## HISTORIC AND DESIGN REVIEW COMMISSION

September 19, 2018

**HDRC CASE NO:** 2018-432  
**ADDRESS:** 827 LAMAR ST  
**LEGAL DESCRIPTION:** NCB 1368 BLK 5 LOT 20  
**ZONING:** R-6, H  
**CITY COUNCIL DIST.:** 2  
**DISTRICT:** Dignowity Hill Historic District  
**APPLICANT:** Oscar Santana/JAS Builder  
**OWNER:** McCleskey Holdings LLC  
**TYPE OF WORK:** Construction of a side and rear addition, window replacement  
**APPLICATION RECEIVED:** August 27, 2018  
**60-DAY REVIEW:** October 26, 2018  
**REQUEST:**

The applicant is requesting a Certificate of Appropriateness for approval to:

ROOF PLAN  
SCALE: 1/4" = 1'-0"

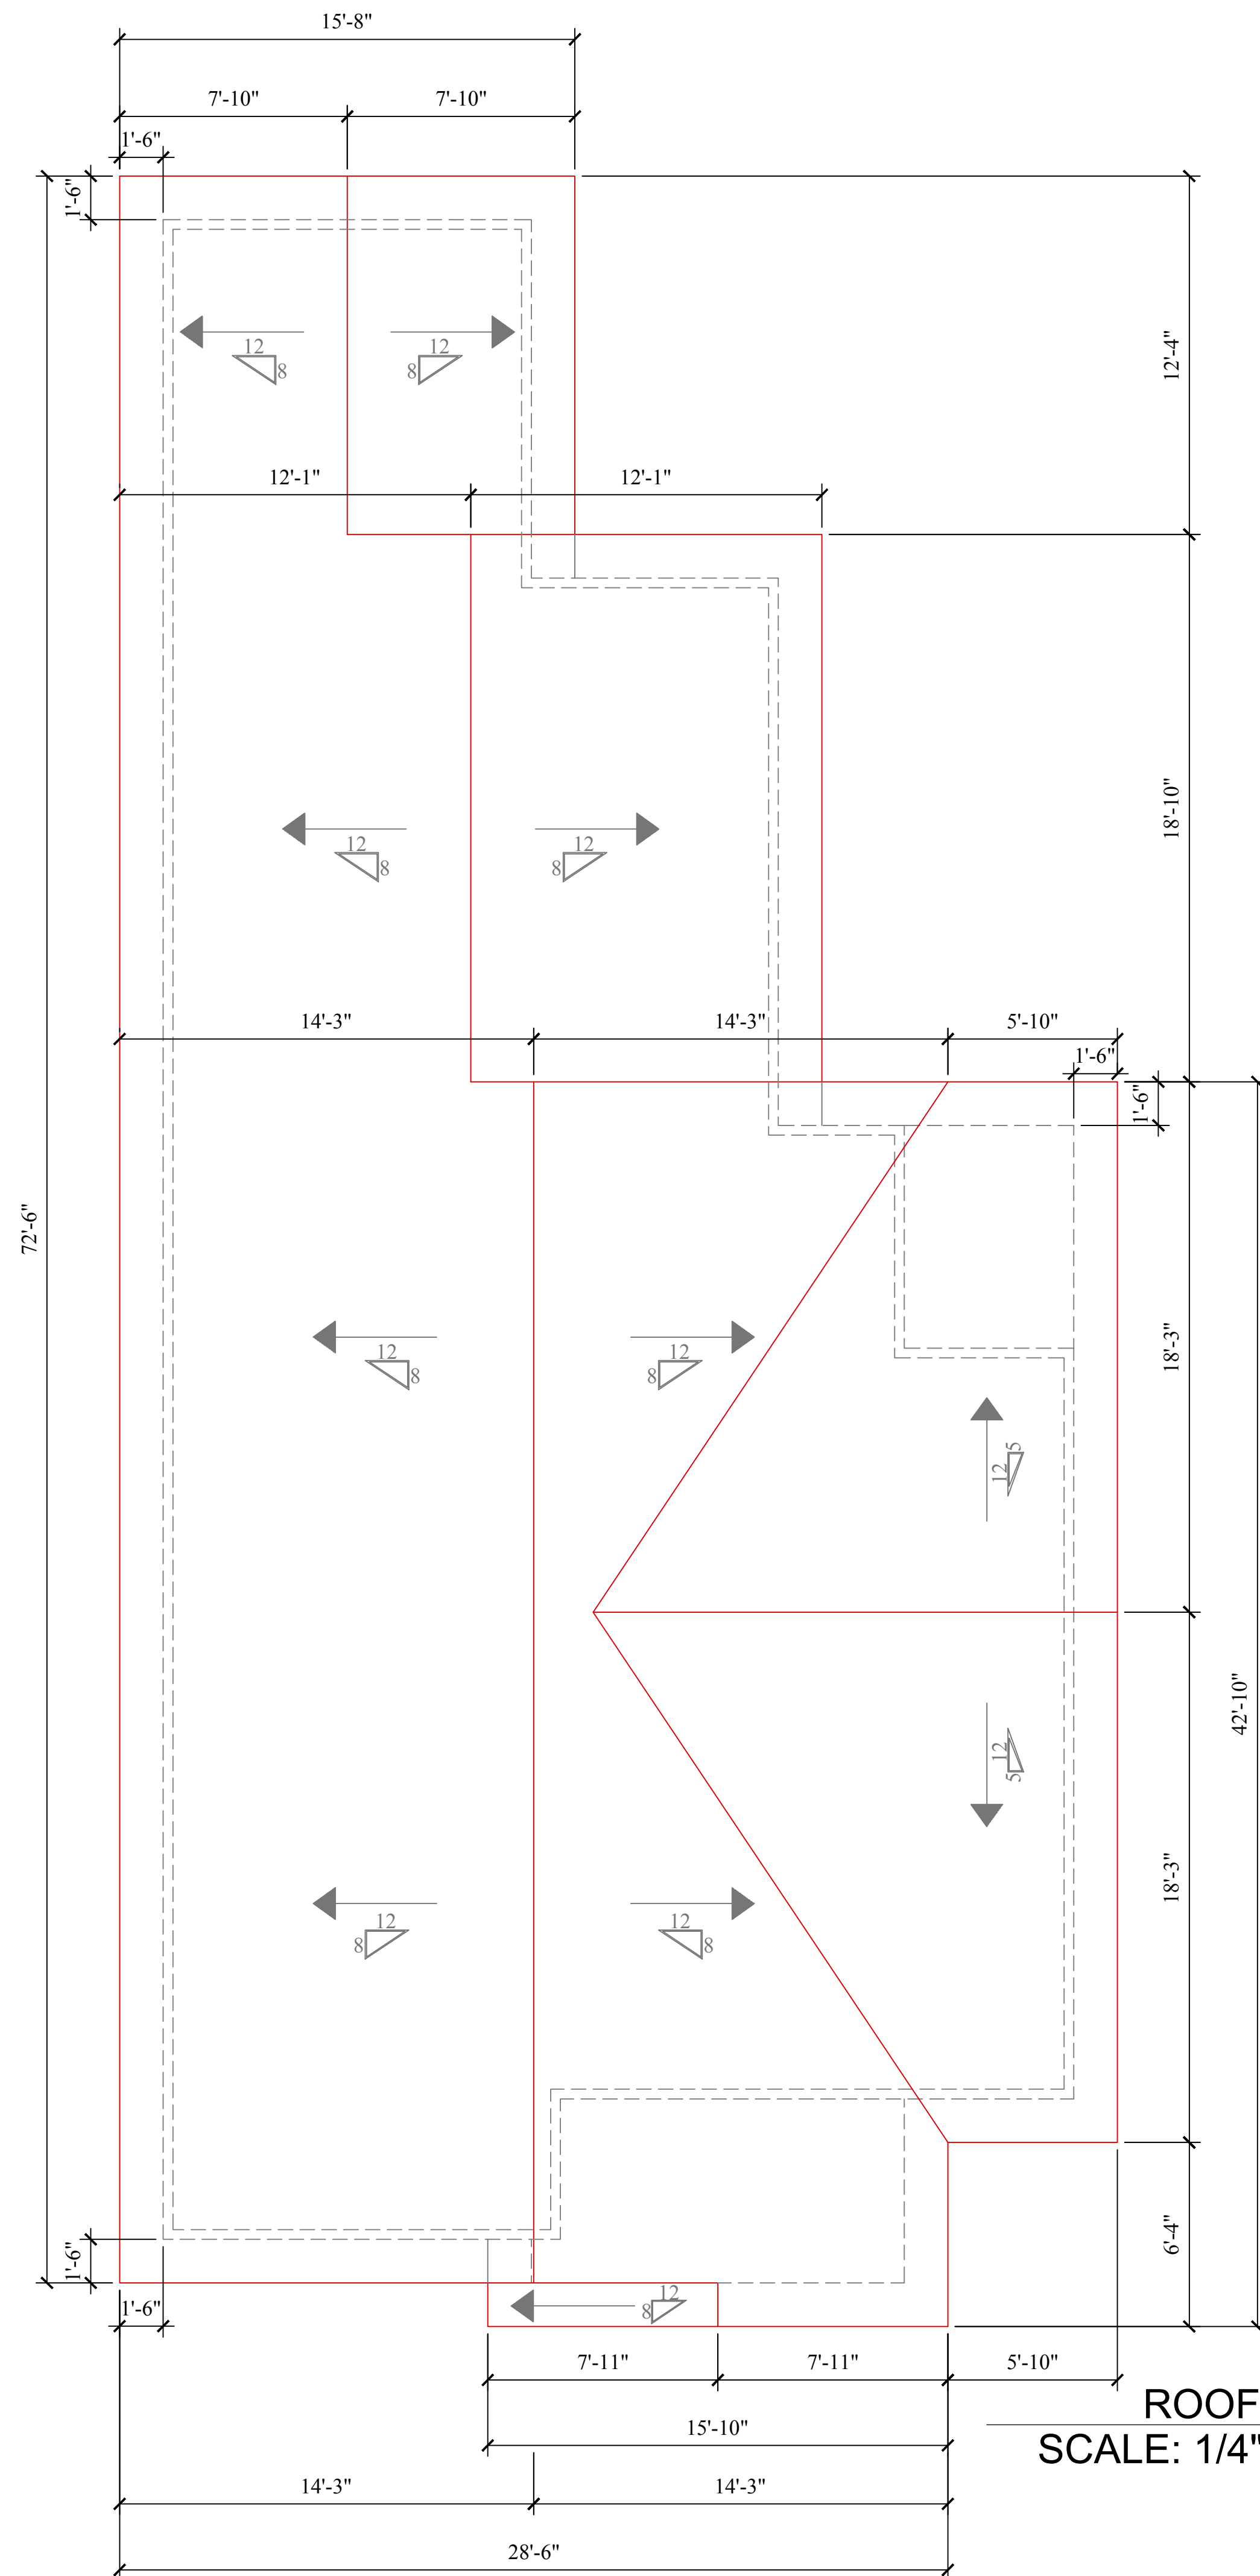
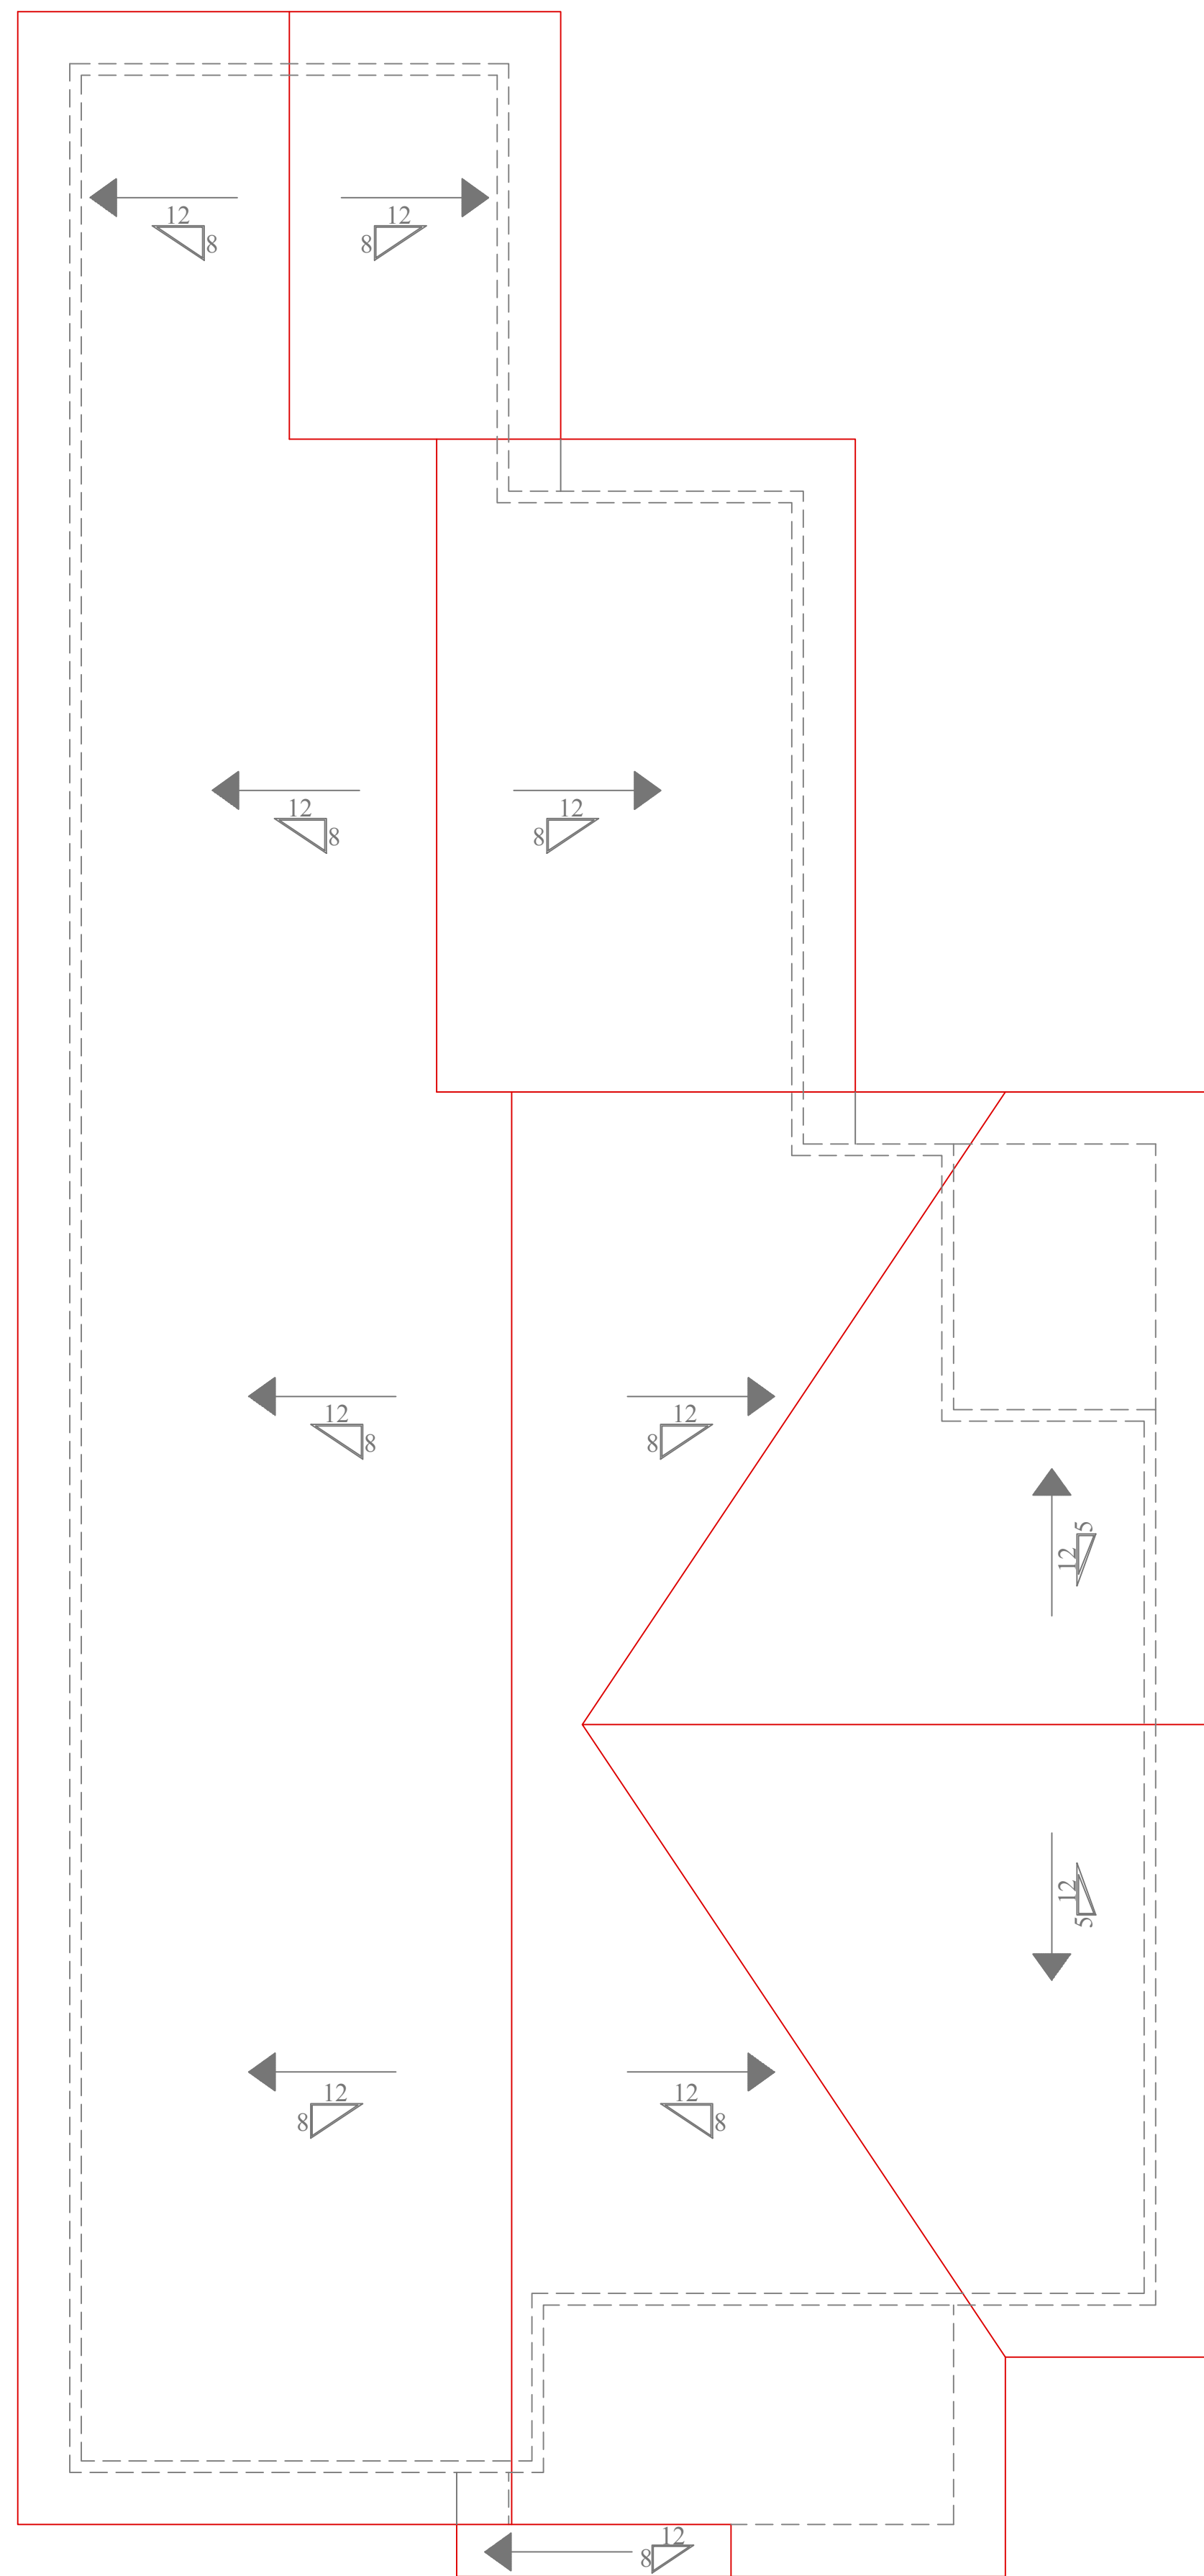
- e. ROOF FORM – The applicant has proposed a rear facing gabled roofs of various heights. The proposed pitch is to match that of the historic structure’s clipped gable roof. Staff finds the proposed roof forms to be appropriate.

# Material 827 Lamar

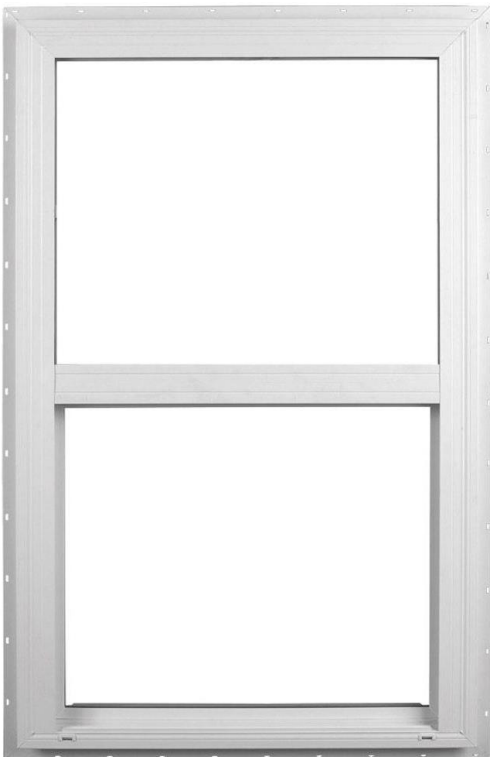
- h. **MATERIALS** – The applicant has proposed materials that include an asphalt shingle roof, vinyl windows and wood siding (117 profile). Staff finds the installation of the asphalt shingle roof and wood siding appropriate; however, the proposed vinyl windows are not consistent with the Guidelines for Additions 3.A.1., which notes that materials that match in type, color and texture should be used.

- i. **WINDOW MATERIALS** – As noted in finding h, the applicant has proposed vinyl windows. Staff finds that wood or aluminum clad wood windows should be installed that feature meeting rails that are no taller than 1.25” and stiles no wider than 2.25”. White manufacturer’s color is not allowed, and color selection must be presented to staff. There should be a minimum of two inches in depth between the front face of the window trim and the front face of the top window sash. This must be accomplished by recessing the window sufficiently within the opening or with the installation of additional window trim to add thickness. Window trim must feature traditional dimensions and an architecturally appropriate sill detail. Window track components must be painted to match the window trim or concealed by a wood window screen set within the opening.

- i. That wood or aluminum clad wood windows should be installed that feature meeting rails that are no taller than 1.25” and stiles no wider than 2.25”. White manufacturer’s color is not allowed, and color selection must be presented to staff. There should be a minimum of two inches in depth between the front face of the window trim and the front face of the top window sash. This must be accomplished by recessing the window sufficiently within the opening or with the installation of additional window trim to add thickness. Window trim must feature traditional dimensions and an architecturally appropriate sill detail. Window track components must be painted to match the window trim or concealed by a wood window screen set within the opening.
